Conceptual Review Agenda

Schedule for 04/15/13 to 04/15/13

Re: 302 Meldrum - Microbrewery

Description of project: This is a request to utilize an existing structure as a microbrewery located at 302 North Meldrum Street (Parcel # 97111-37-001). Changes to the site include the addition of a deck and ADA ramp, bike parking and a silo. The site is located in the Civic Center subdistrict of the Downtown (D) Zone District and also within the Transit Oriented Development Overlay (TOD). Microbreweries are subject to Planning & Zoning Board (Type 2) review in the Civic Center/Downtown Zone District.

RAM CROSSING EAST
EXISTING IMPERVIOUS AREA
PHASE 1 74,100 SF = 63%
PHASE 2 115,100 SF = 69%
PHASE 3 52,800 SF = 74%
TOTAL 5.6 AC = 68%

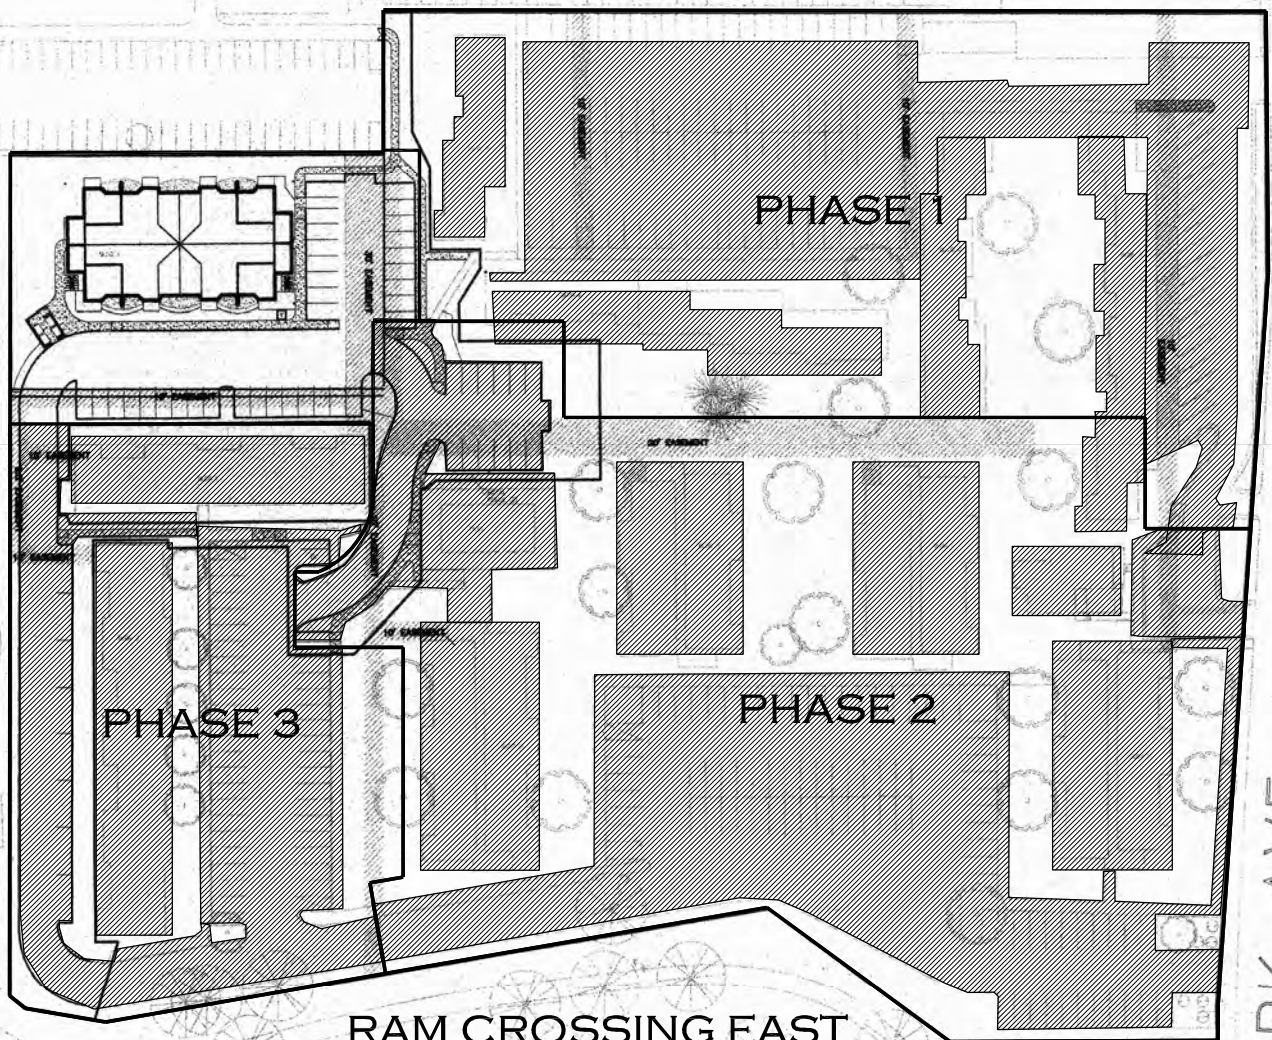
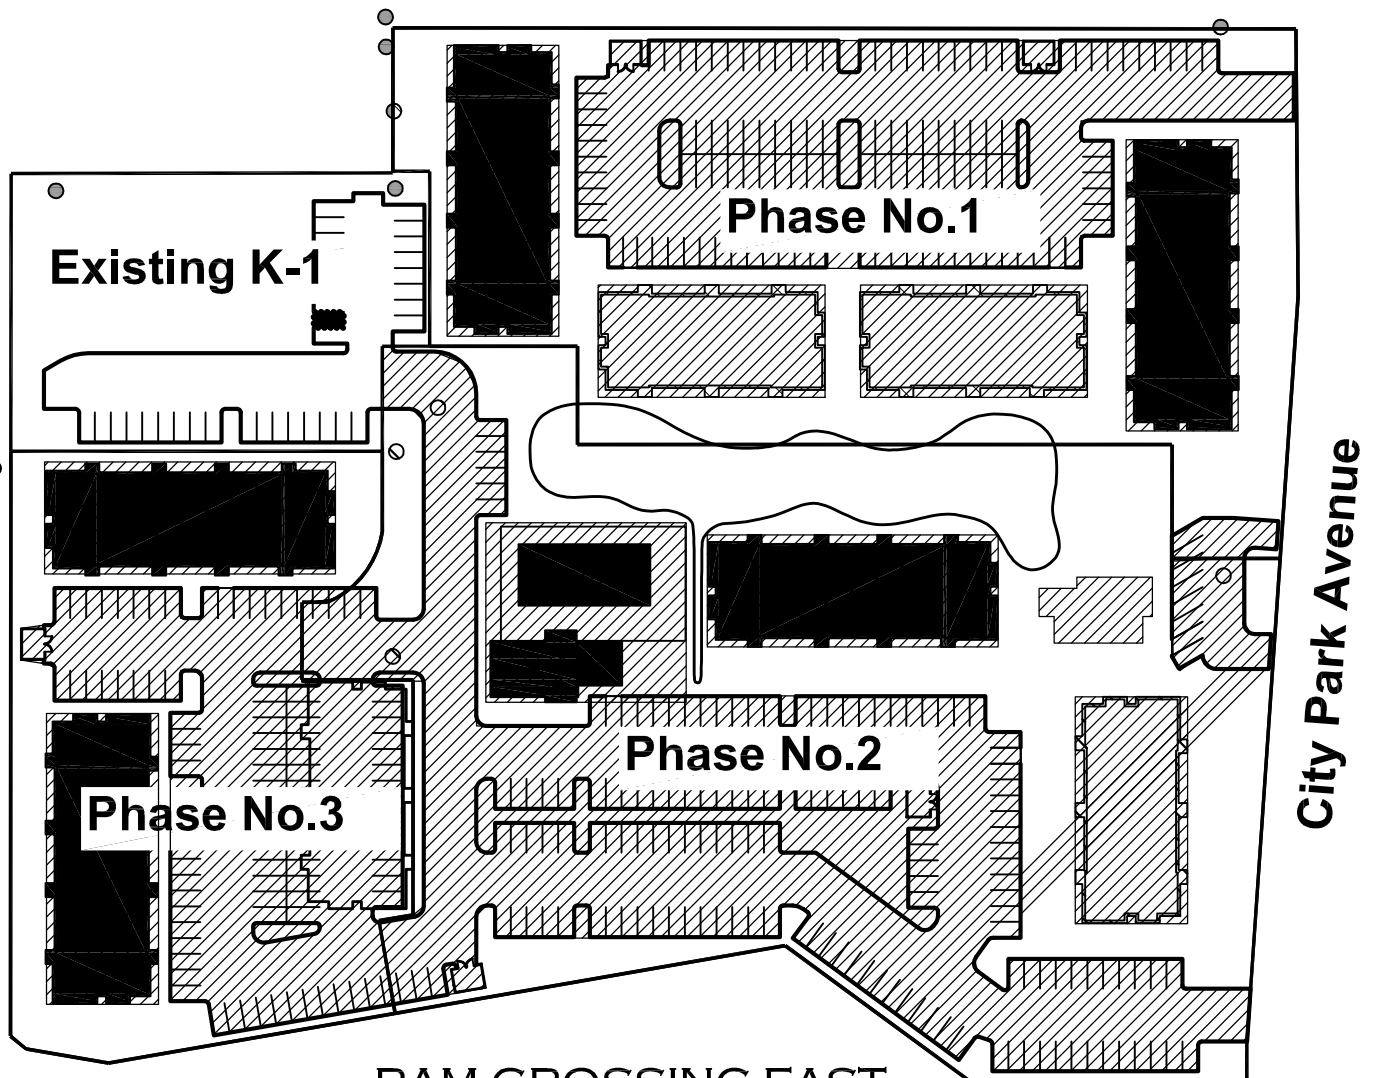
11. In the Old Town Drainage basin 5000 sq.-ft. increase in impervious area is allowed if the site is not being scraped. Technically not all of it is being removed but a lot of it is. Since some phases increase the impervious area and others decrease it the design engineer needs to evaluate the flow rates to the existing concentration points. Also the design rainfall has changed since this site was developed and must be considered. A variance may be needed but the design engineer needs to show a hardship to justify not using the new rainfall. If there is an increase in the runoff rates to the concentration points the engineer will need to propose methods to mitigate it or show how the runoff can still safely pass through the site. Therefore a drainage study is required to document the changes and the mitigation. It must be prepared by an engineer registered in the state of Colorado.
